SB, Starter cpl, K970, K970 II, K970 Ring, K970 II Ring, K970 Chain, K970 II Chain, K970 Rescue, K970 II Rescue, 2014-03

Affected models

K970, All models

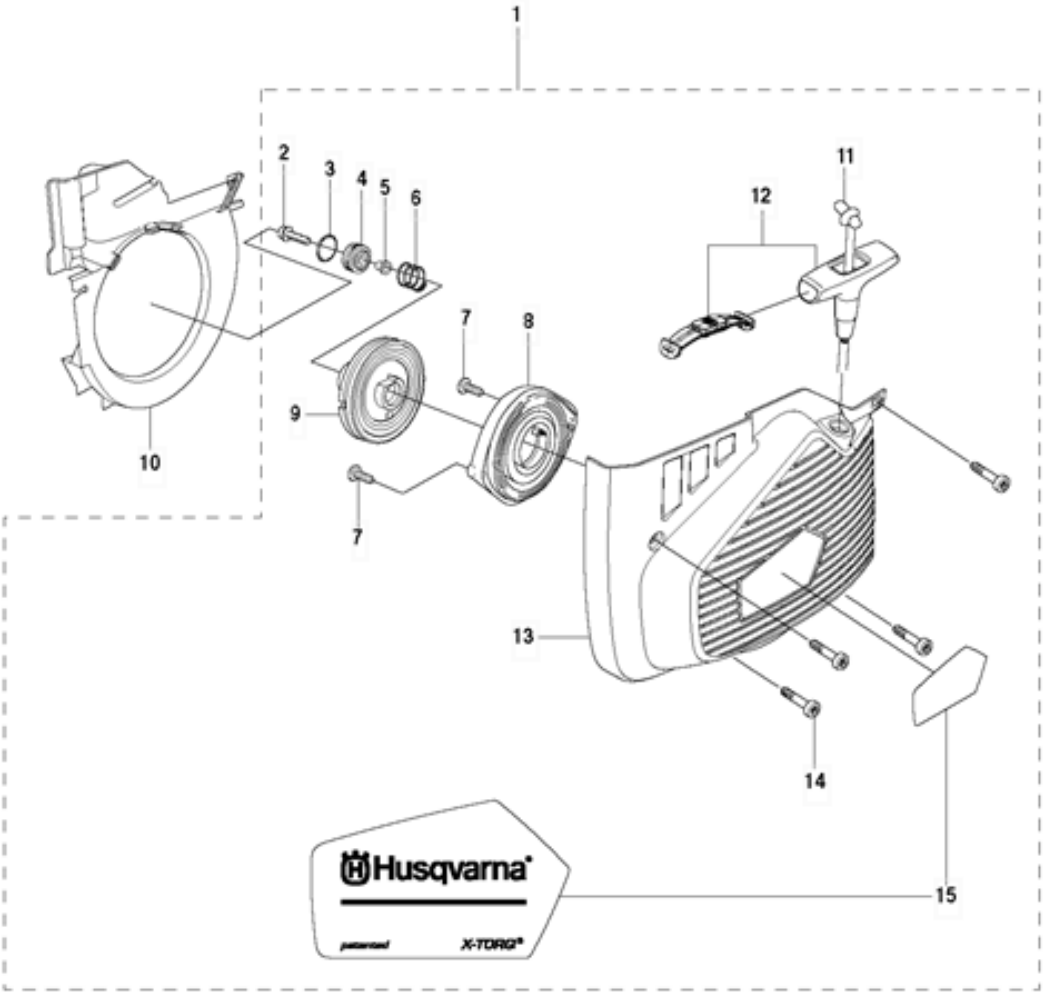
Starter cpl, 574 50 73-07 (pos. 1) does not include “COOLING AIR CONDUCTOR”, 544 28 75-02 (pos. 10) anymore.

The Starter is compatible with earlier models of K970 by removing the skin for the decompression valve.
